**AGENDA ITEM:**    **201401611** - 5801 Roswell Road, *Applicant: Zahedi, Inc.*, to rezone the subject property from C-1 (Community Business District) conditional to C-1 (Community Business District) for the development of to allow an addition to the existing commercial building, with concurrent variances

Agenda Item: **201401611 5801 Roswell Road** a request to rezone the subject property from C-1 (Community Business District) to C-1 (Community Business District) to allow for a 2,100 square foot addition to the existing building, with concurrent variances.

**APPROVAL CONDITIONAL** of a request to rezone the subject property from C-1 (Community Business District) to C-1 (Community Business District) to allow for a 2,100 square foot addition to the existing building and **DENIAL** of the concurrent variances.

**SITE PLAN**  
 6801 CARPENTER DRIVE  
 LAND LOT 90 DISTRICT 17  
 FULTON COUNTY, GEORGIA

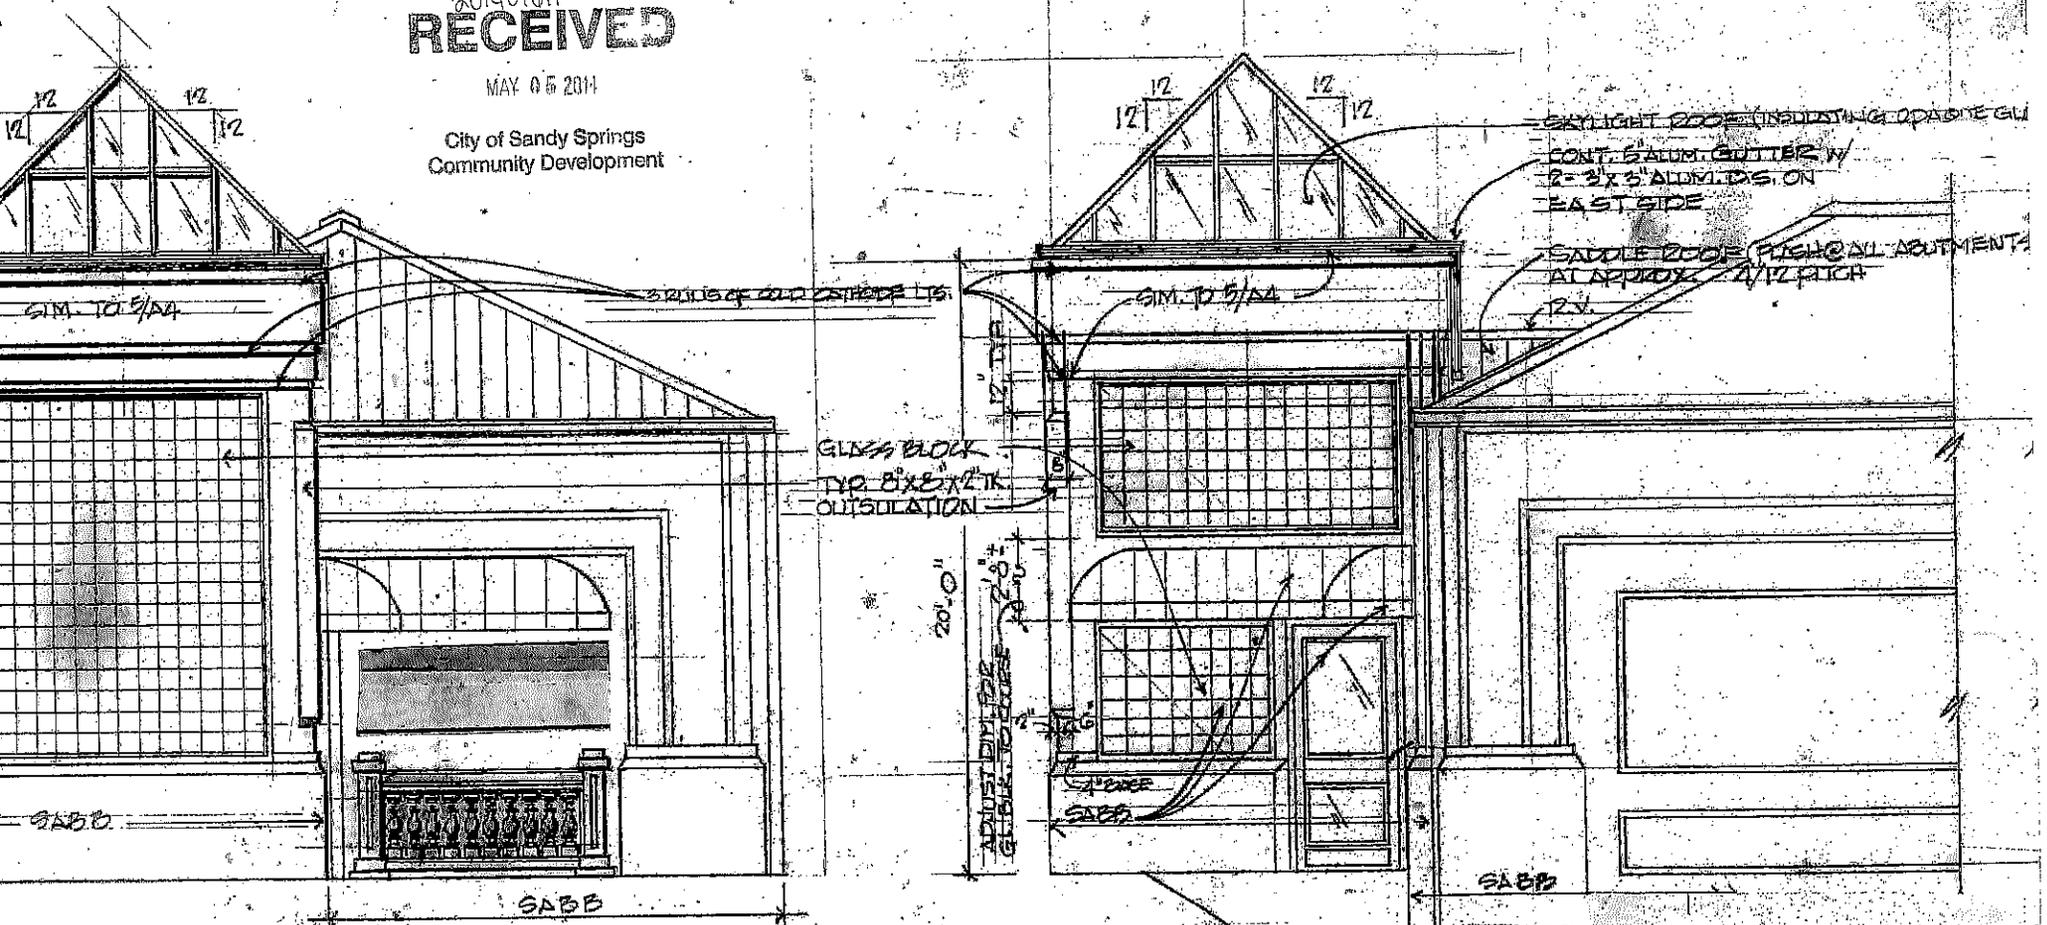
*Staff is of the opinion that the reduction of the landscape strip is in not harmony with the intent of the zoning ordinance and would cause a detriment to the public. The landscape strip was able to be maintained through the construction of the existing building. . Additionally, the majority of the landscaping area shown on the site plan is on the adjacent property. Therefore, based on these reasons, the staff recommends DENIAL of this variance request.*

*Staff is of the opinion that the request to reduce the sidewalk with from nine (9) feet to five (5) feet and allow one (1) light pole on the corner of Roswell Road and Carpenter Drive is in not harmony with the intent of the zoning ordinance and could cause a detriment to the public. The intent of the Ordinance and the City Center Master Plan is to create a safe and inviting walkable area with in the Main Street Overlay District. This property is providing a connection to the south side of I-285 and tie into the new bridge at Roswell Road and I-285. Reducing the sidewalk in this location would hinder the pedestrian connection. Therefore, based on these reasons, the staff recommends DENIAL of this variance request.*

*Staff is of the opinion that the request to reduce the required parking from thirty (30) spaces to nineteen (19) spaces is in not harmony with the intent of the Zoning Ordinance. The Main Street Overlay allows for a parking reduction of up to 1.5 spaces per 1000 when streetscape is installed. The applicant is requesting a variance from the required streetscape and therefore not meeting the intent of the Zoning Ordinance. Inadequate parking would cause a detriment to the surrounding property owners. Therefore, based on these reasons, the staff recommends DENIAL of this variance request.*
